Notice of Intent

Type of Action: Plug and Abandonment

Operator: Cross Timbers Energy LLC
Lease: NMNM 0003733
Well(s): Breech 382, US Well # 30-039-20912
Location: SESW Sec 24 T26N R07W (Rio Arriba, NM)
Sundry Notice ID #: 2881358

Breech 382 - 3003920912

Proposed P&A WBD

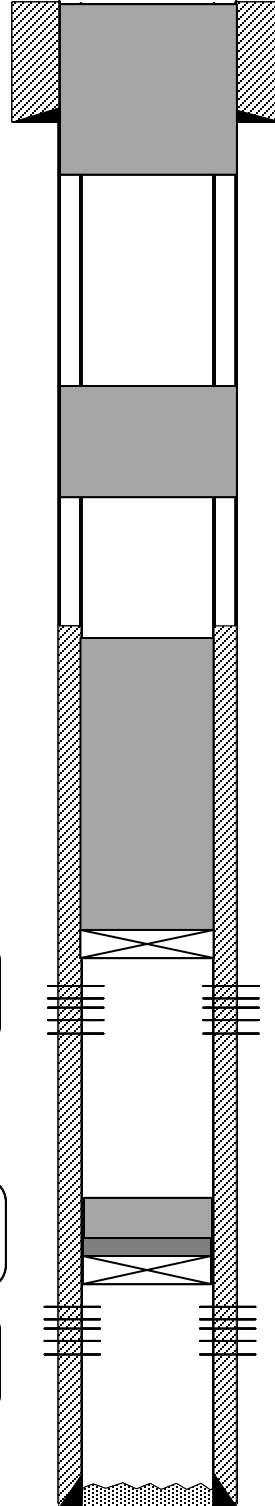
1. Plugging operations authorized are subject to the attached "General Requirements for Permanent Abandonment of Wells on Federal and Indian Lease."
2. The following modifications to your plugging program are to be made:
 - a. Add addition cement above the CIBP at 3425', minimum depth 3375'.
 - b. Modify Plug 2. Make the TOC 1820' to cover the BLM Geologist's pick for the Ojo Alamo at 1920'.
3. **Notification:** Farmington Office is to be notified at least 24 hours before the plugging operations commence at (505) 564 7750.

-The minimum cement top over the Chacra perfs CIBP is 3390' if it is placed by a dump bailer, 3375' if it is placed by pipe.

Modify Plug 2. Make the TOC 1820' to cover the BLM geologist's pick for the Ojo Alamo.

Plug 2 (PC Perf/FC/Kirtland/Ojo Alamo) – CIBP Set @ ~2620' – Pump 60 sx balance plug on top of CIBP (2620-1820')

Plug 1 (Chacra) – Tag exist cmt to confirm depth, top off 9 sx cmt (3387-3275')
